Product change notification (PCN)

Title / short description	Approval extension and printing change on Heavycon HC-M-02-03-04 modules and HC-HS-06 inserts
Affected article category	Connector
Change category	Approval, Form and appearance
Change number	CAF250106-00
Reason for PCN/PDN Revision

CAF250106

Visual Changes: 1031080

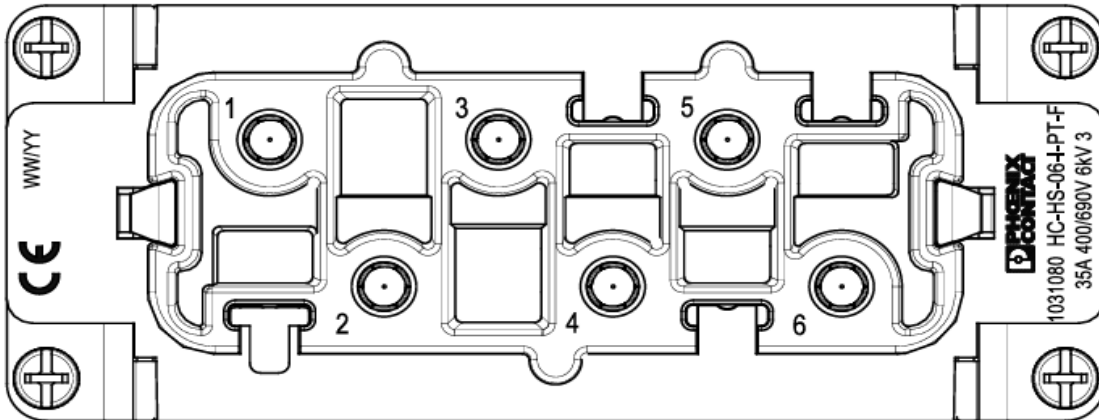
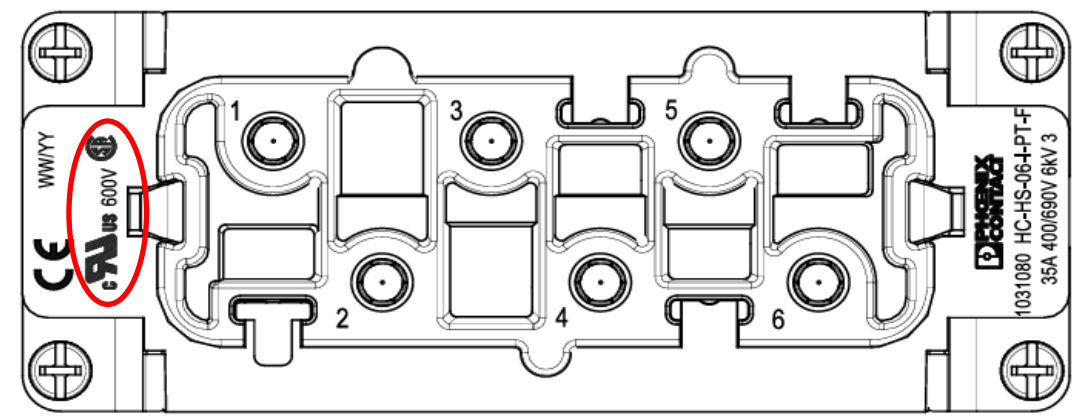
V/C 0 (current)

V/C 1 (new)

Visual Changes: 1031082

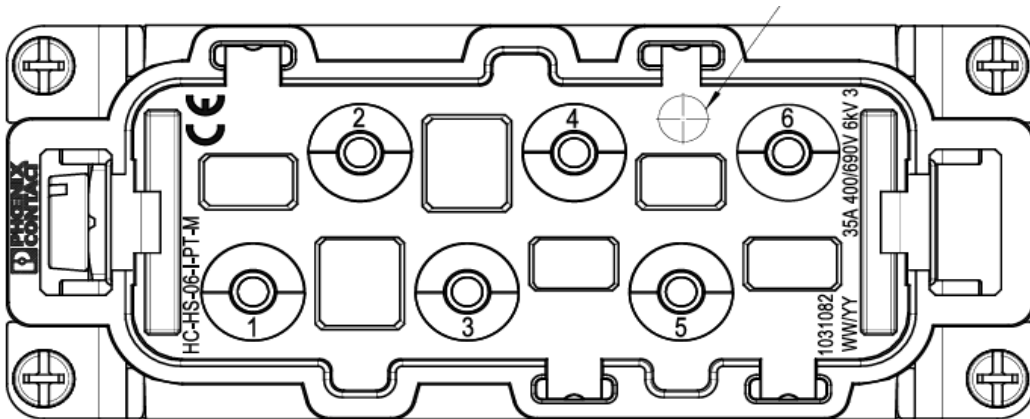
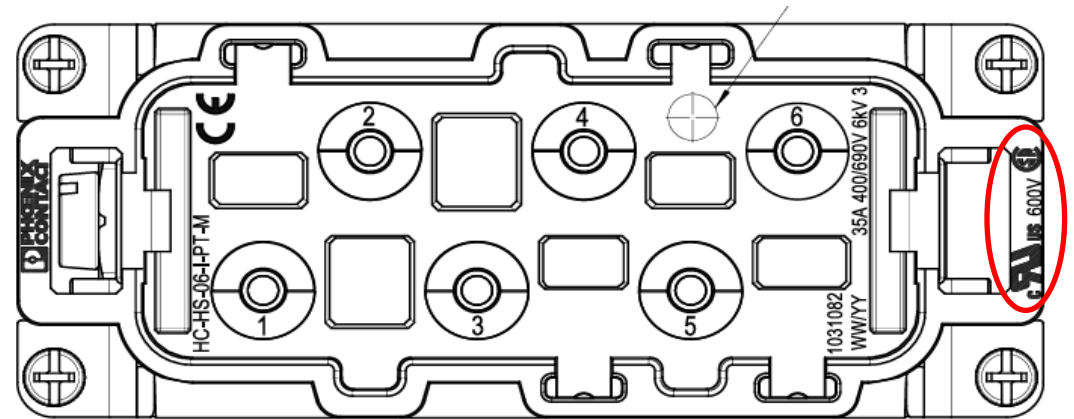
V/C 0 (current)

V/C 1 (new)

Visual Changes: 1424218

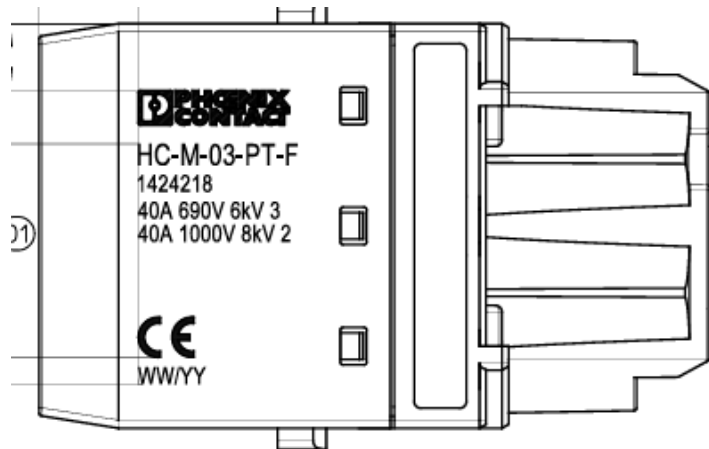
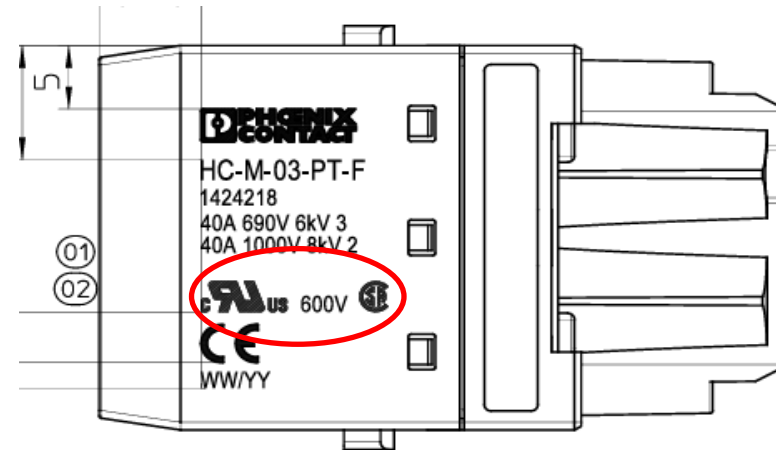
V/C 0 (current)

V/C 1 (new)

Visual Changes: 1424219

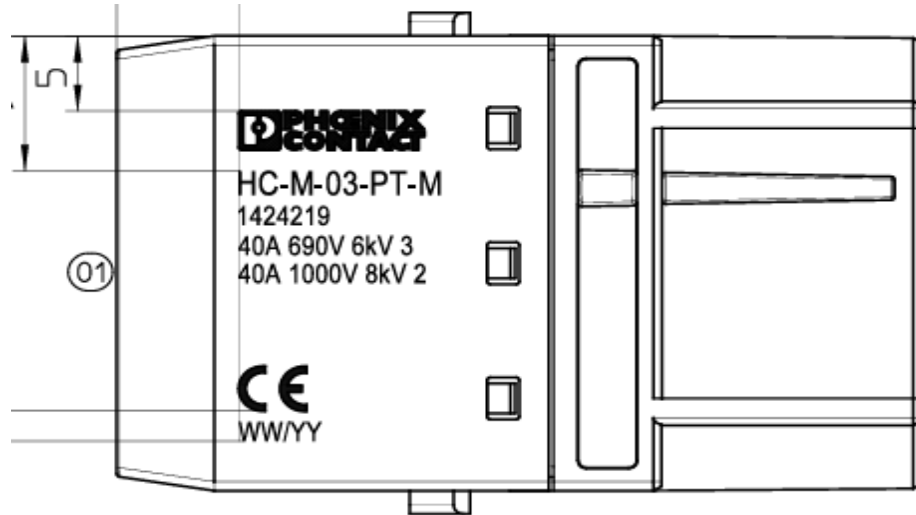
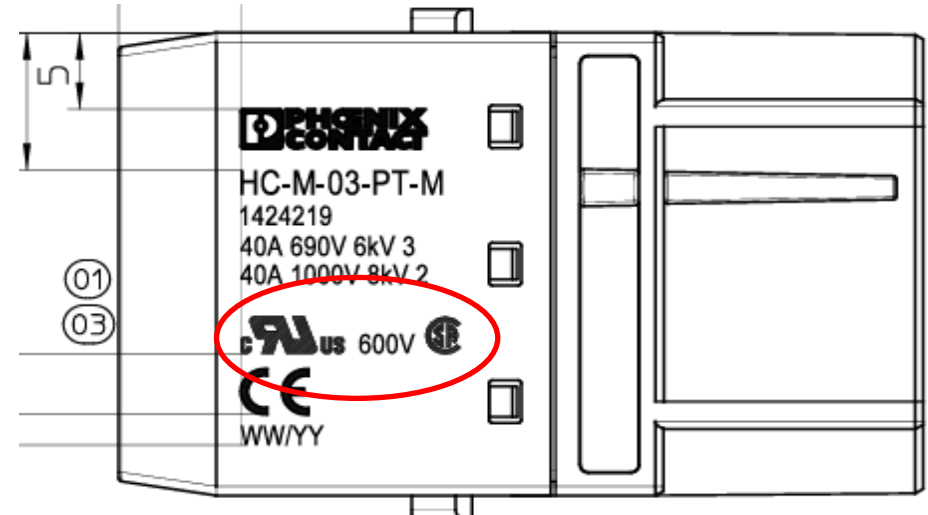
V/C 0 (current)

V/C 1 (new)

Visual Changes: 1424220

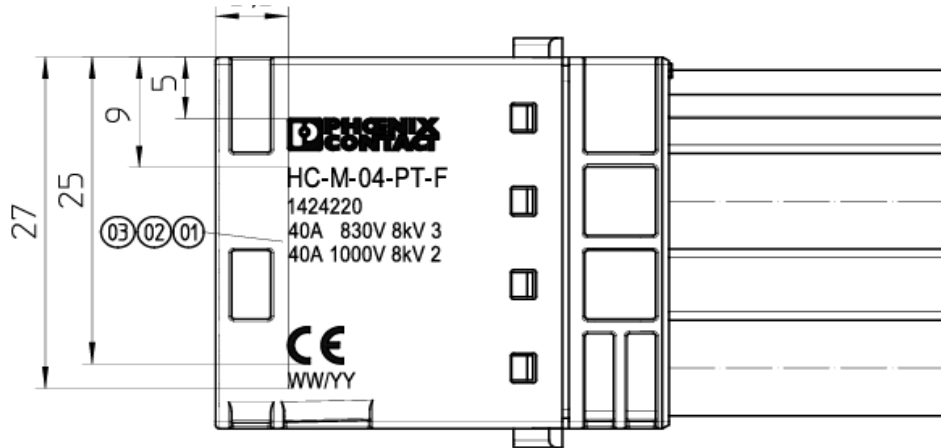
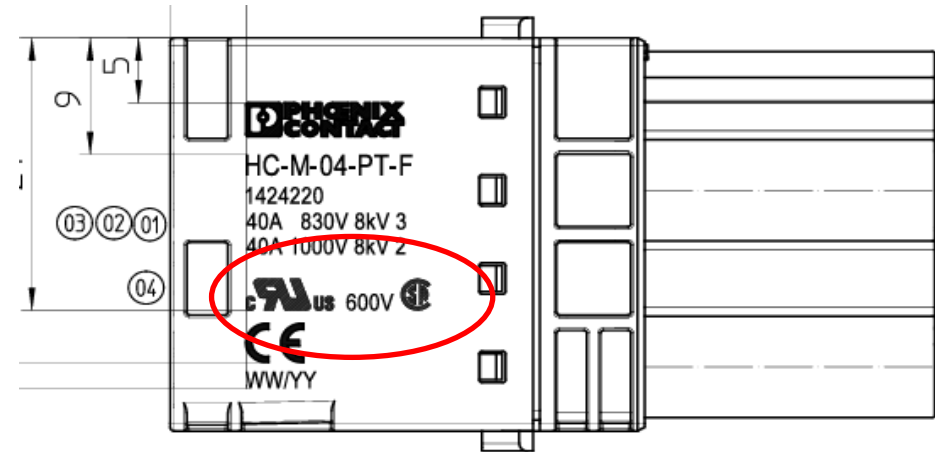
V/C 0 (current)

V/C 1 (new)

Visual Changes: 1424221

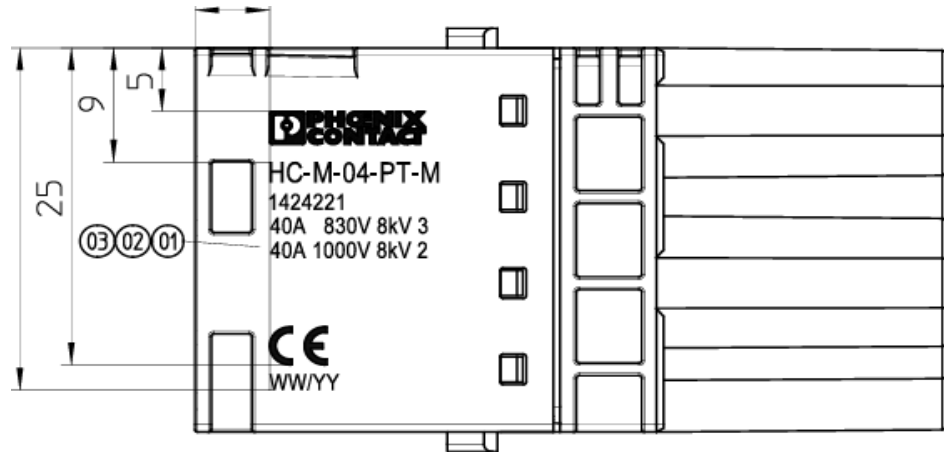
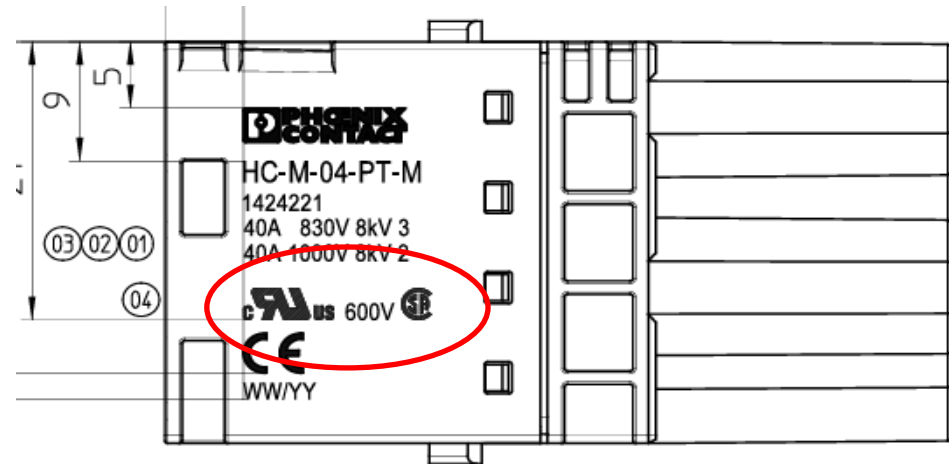
V/C 0 (current)

V/C 1 (new)

Visual Changes: 1424222

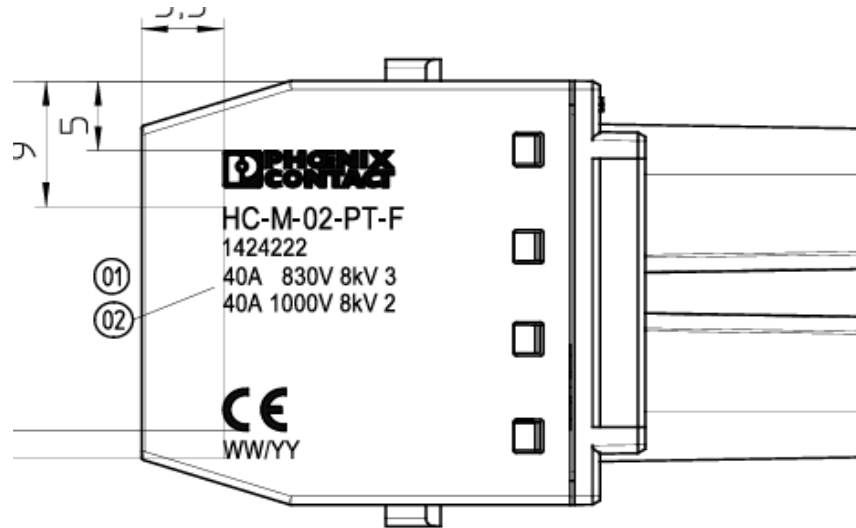
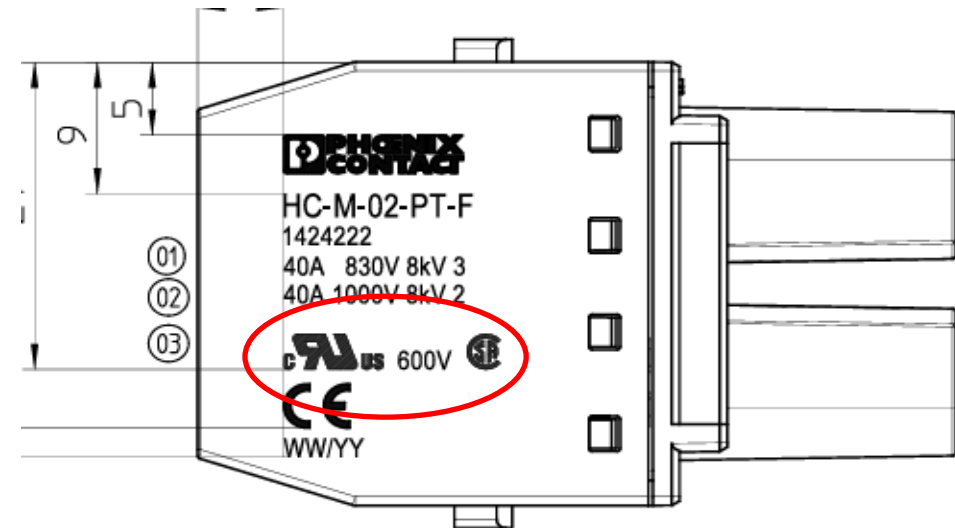
V/C 0 (current)

V/C 1 (new)

Visual Changes: 1424223

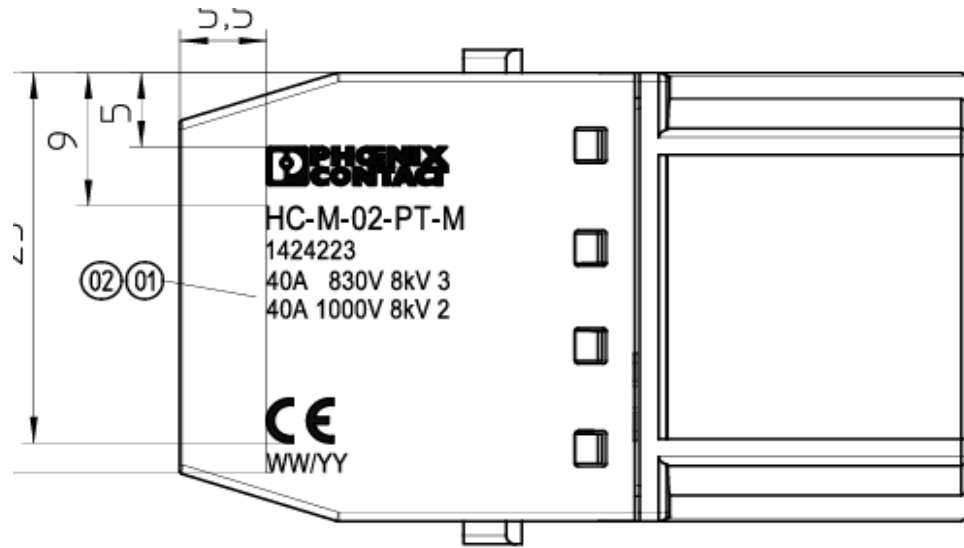
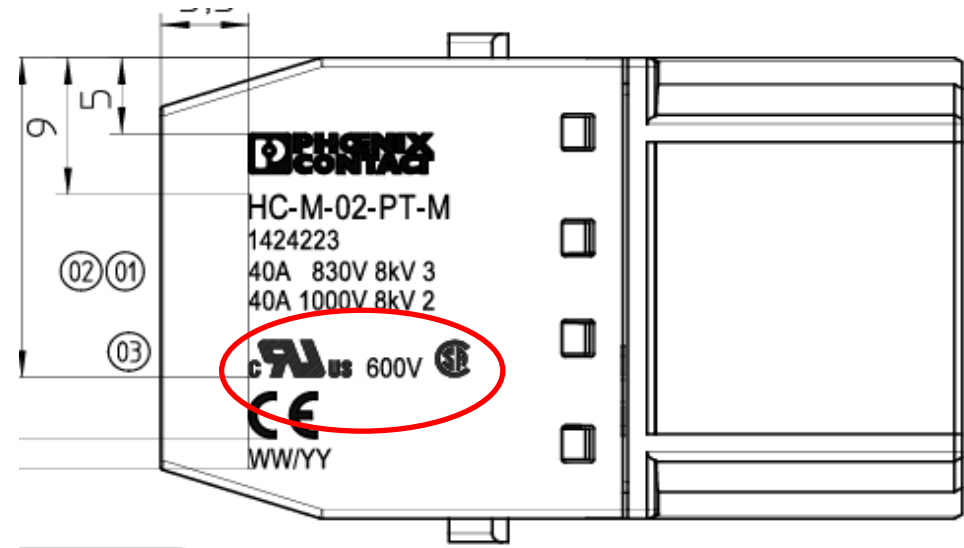
V/C 0 (current)

V/C 1 (new)
